Safety Defect and Noncompliance Report Guide for Vehicles
PART 573 Defect and Noncompliance Report⁽¹⁾

05V-107
(12 pages)

**WARRANTY
BULLETIN**

DATE : FEBRUARY 2005	SECTION : 14 - Steering
EXPIRATION: FEBRUARY 2007	
SUBJECT : INSPECTION & REPLACEMENT OF POWER STEERING PRESSURE HOSE

FIGURE 1: INSTALLATION OF NYLON TIES (TYPICAL)

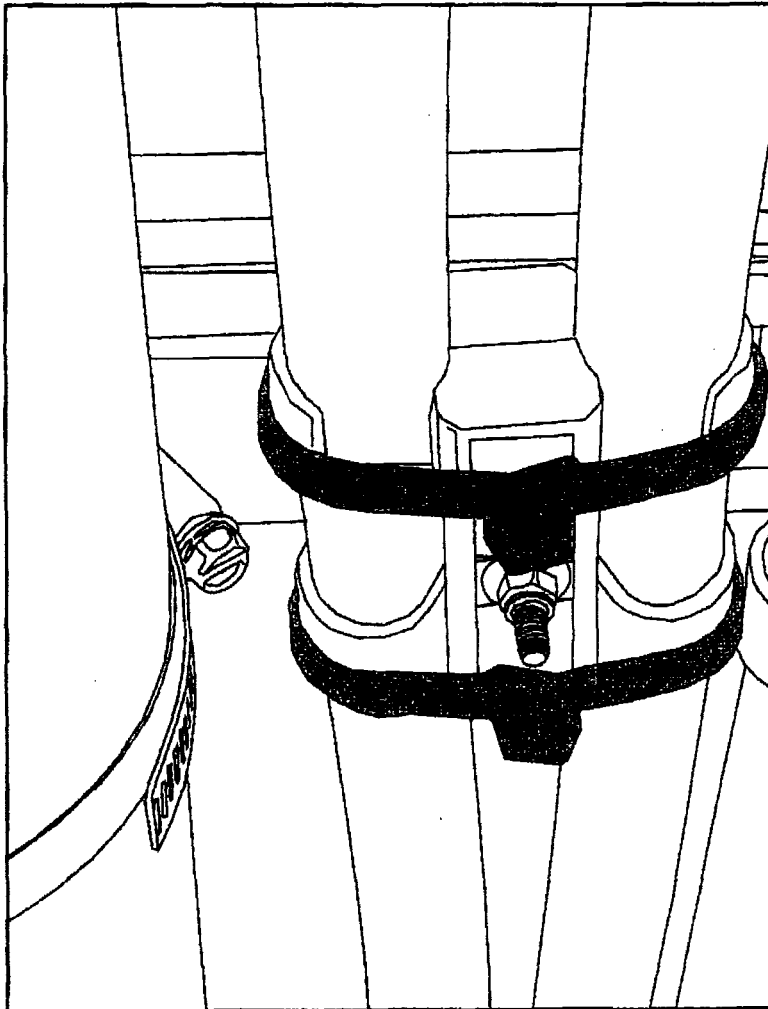
1. Fix pressure hose to supports using nylon ties (Refer to figure 1).

2. If the pressure hose oozes with oil or premature hose wear has reached the wire reinforcement, replace the entire power steering pressure hose (161164).

FIGURE 2: H3 OR XL2 VEHICLES

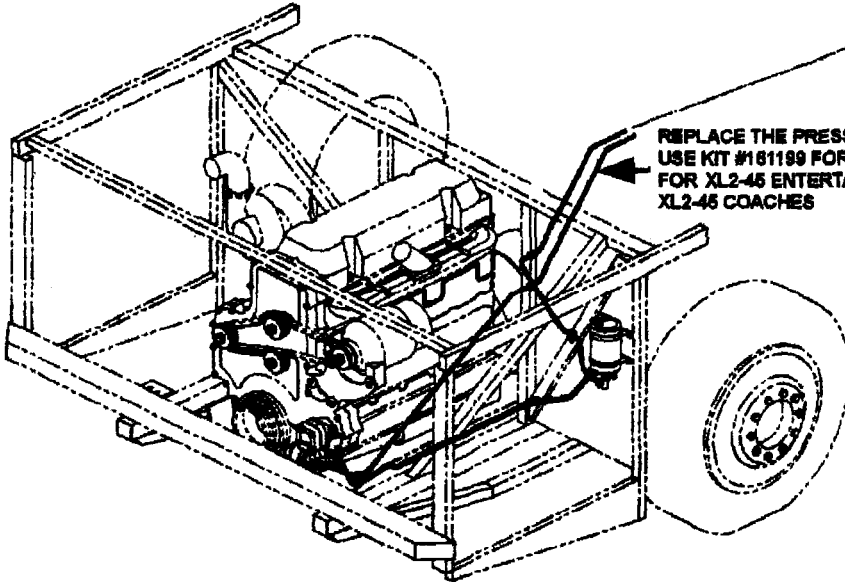
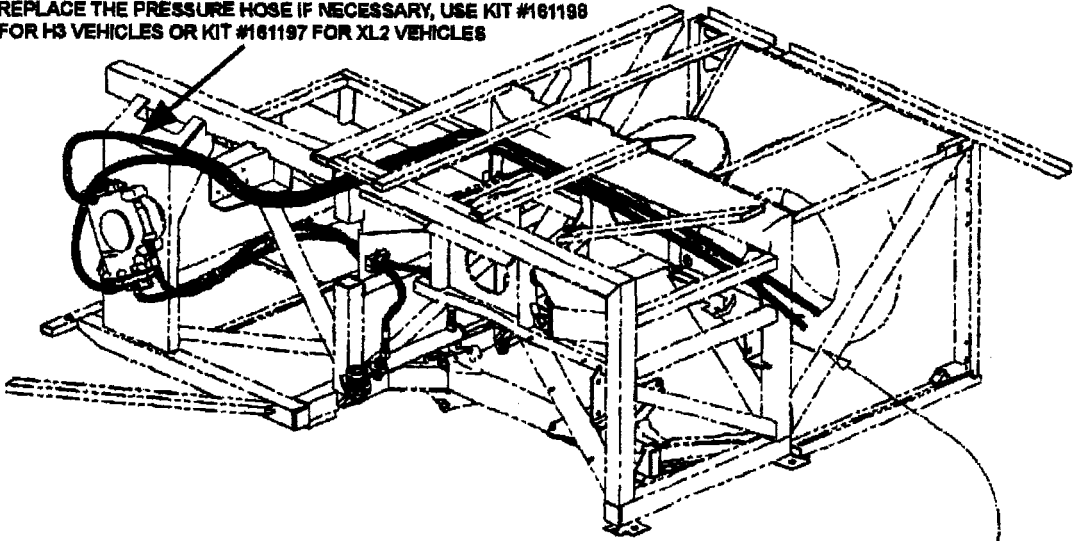
REPLACE THE PRESSURE HOSE IF NECESSARY, USE KIT #161198 FOR H3 VEHICLES OR KIT #161197 FOR XL2 VEHICLES

REPLACE THE PRESSURE HOSE IF NECESSARY, USE KIT #161199 FOR H3 VEHICLES, HOSE #161027 FOR XL2-45 ENTERTAINER, HOSE #161137 FOR XL2-45 COACHES

1. Put a container into place below the power steering gear, and then disconnect the pressure hose from the power steering gear. Cover fittings to prevent fluid contamination.
2. Measure the new hose length (161196) supplied in kit #161198. Cut and remove the corresponding length of hose from the installed hose.

3. Install the male connector (501456) to the end of the cut hose.
4. Install the new hose between the male connector and the power steering gear.
5. Bleed air from the system as indicated in section 14 of Maintenance Manual.

1. Open the engine compartment door then put a container into place below the power steering pump, and then disconnect the pressure hose from the power steering pump. Cover fittings to prevent fluid contamination.
2. Measure the new hose length (161194) supplied in kit #161199. Cut and remove the corresponding length of hose from the installed hose.
3. Install the male connector (501456) to the end of the cut hose.
4. Install the new hose between the male connector and the power steering pump.
5. Bleed air from the system as indicated in section 14 of Maintenance Manual.

FIGURE 3: H3 VEHICLES

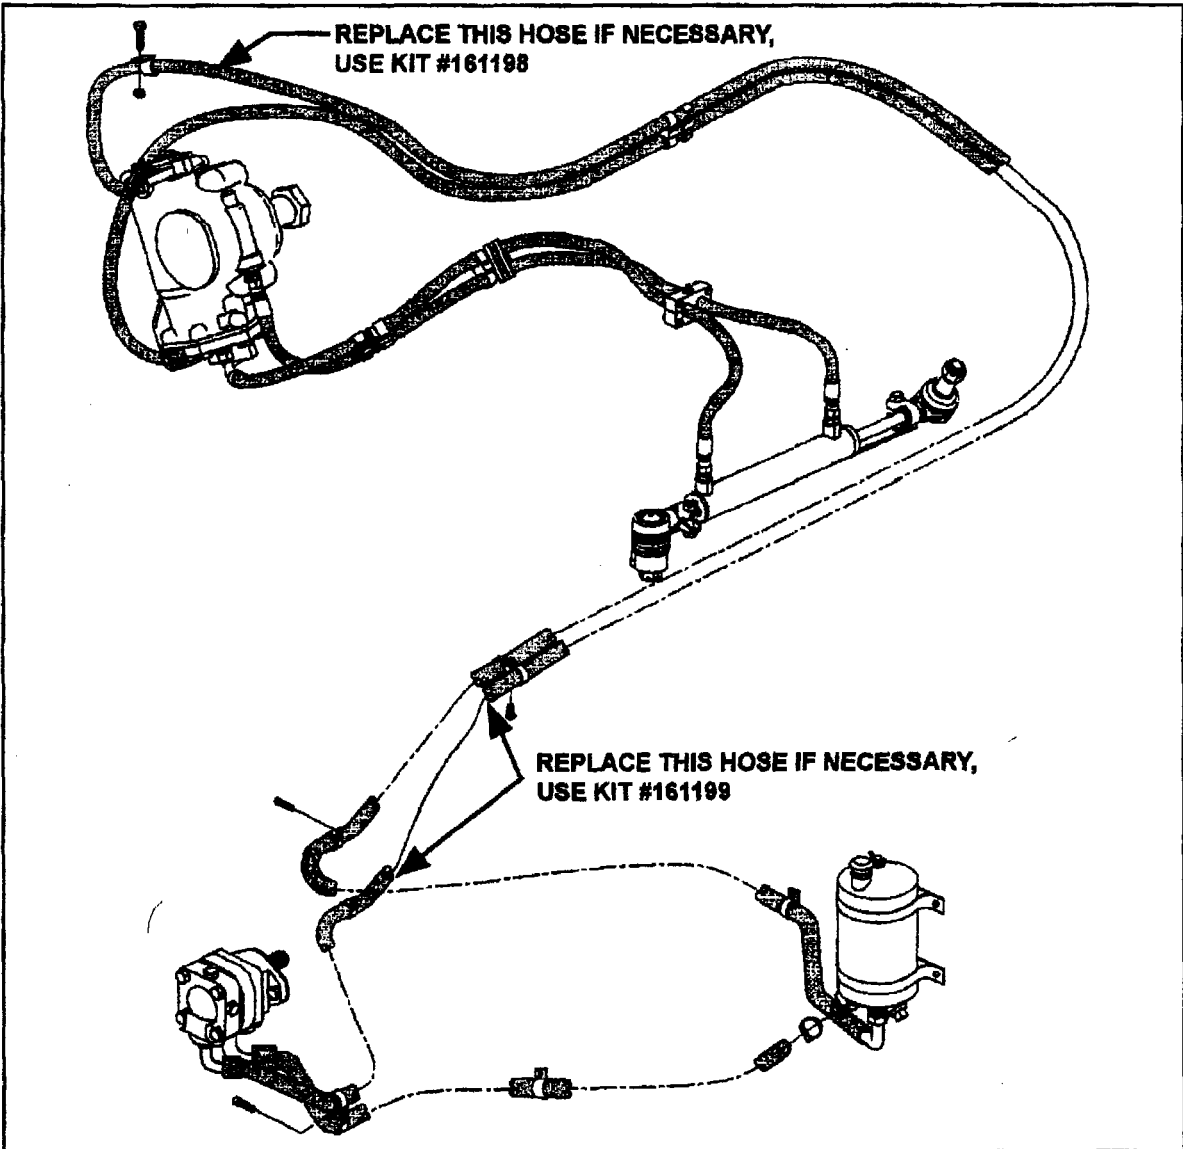
It has come to the attention of Prevost Car Inc. that on the previously mentioned vehicles, premature power steering hose wear located in the engine compartment, baggage compartments and in the front service compartment might occur and thus in the long term cause power steering break down. Inspect the hoses mentioned below and replace them if there is evidence of wear.
